I'm writing to comment on USACE's 2023 SEIS/SEIR for the American River Common Features Project, especially in regards to the inadequate environmental analysis of the plan's impacts on heritage trees. Chapter 19.04.030 of Sacramento County Code defines a "heritage tree" as a "California oak tree growing on any land in Sacramento County, including privately owned land, with a trunk sixty inches or greater in girth measured four and one-half feet above the ground." On page 1-7 of the 2023 ARCF SEIS/SEIR, the Sacramento County Tree Ordinance is listed as one of the state and local plans which govern activities within this project area. There is no other mention of the Sacramento County Tree Ordinance in the 2023 SEIS/SEIR, even though USACE's proposal to remove hundreds of trees in the Contract 3B Area is inconsistent with the goals and purpose of Sacramento County's tree code. As the Sacramento County Tree Ordinance states in chapter 19.04.010, "in order to promote the health, safety, and enhance the beauty and general welfare of Sacramento County," it shall be the policy of the County "to provide for the special protection of heritage and landmark trees within the unincorporated are

Figure 4.1-1. American River Erosion Contract 3B and 4B Land Cover Types

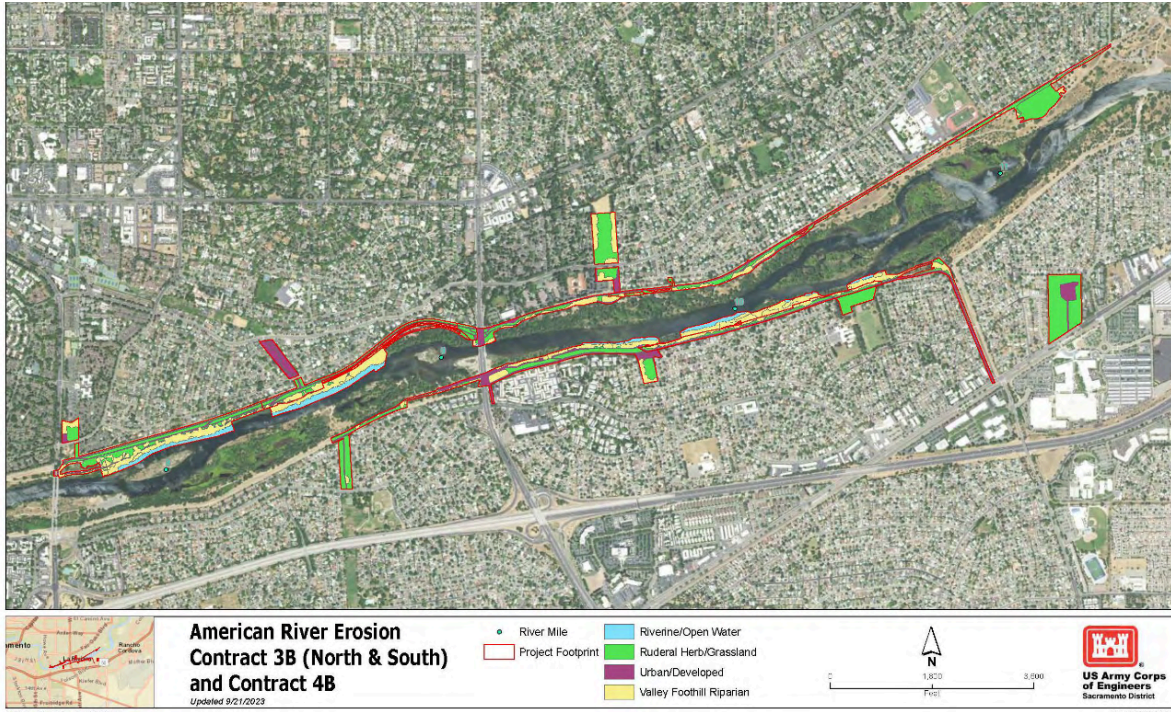
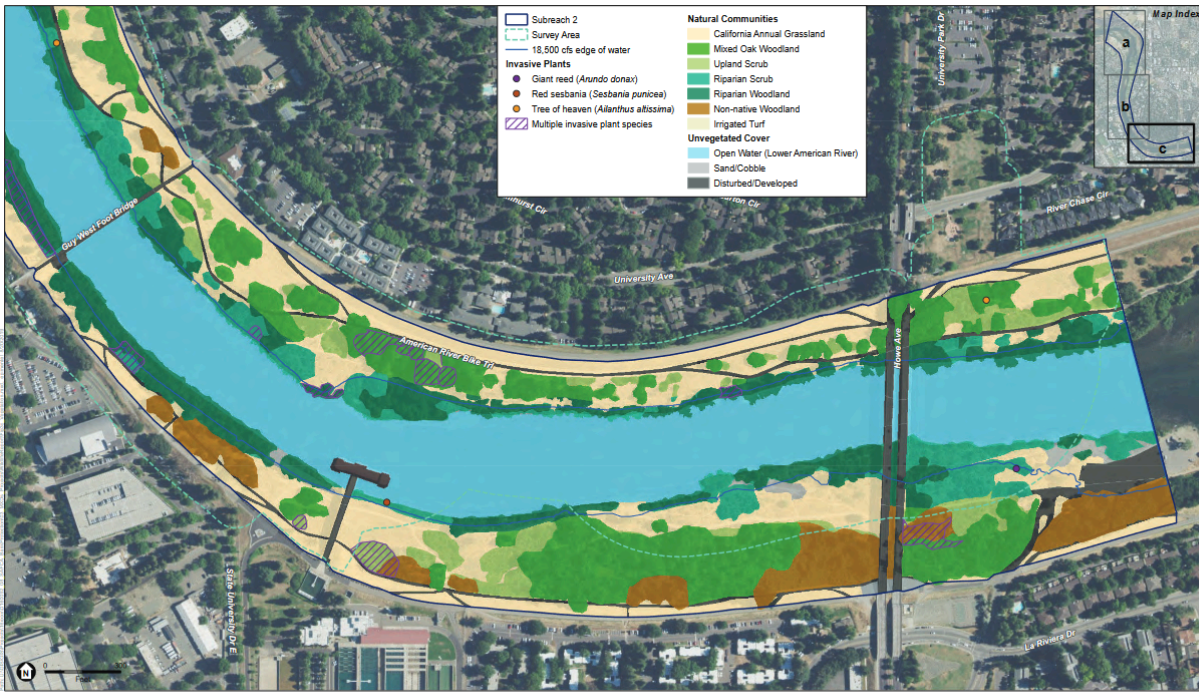
USACE also provides a low-quality image of the various habitats in the project footprint, but fails to distinguish with any detail the different habitats and much tree loss each segment will suffer.

This practice of providing a very low-detail, zoomed out map of the entire project area notably contrasts with the habitat maps USACE provided for previous SEIS/SEIR's, such as American River Contract 2, which provided not only section by section habitat maps, but mapped 13 types of habitat, compared to only 4 for the 2023 SEIS/SEIR. Furthermore, the habitat maps for in American River Contract 2 SEIS/SEIR Appendices identified various types of woodland, including oak woodland, which the map for the 2023 SEIS/SEIR does not do. At the very least, USACE is capable of marking out the areas of the Contract 3B segments which have oak trees.
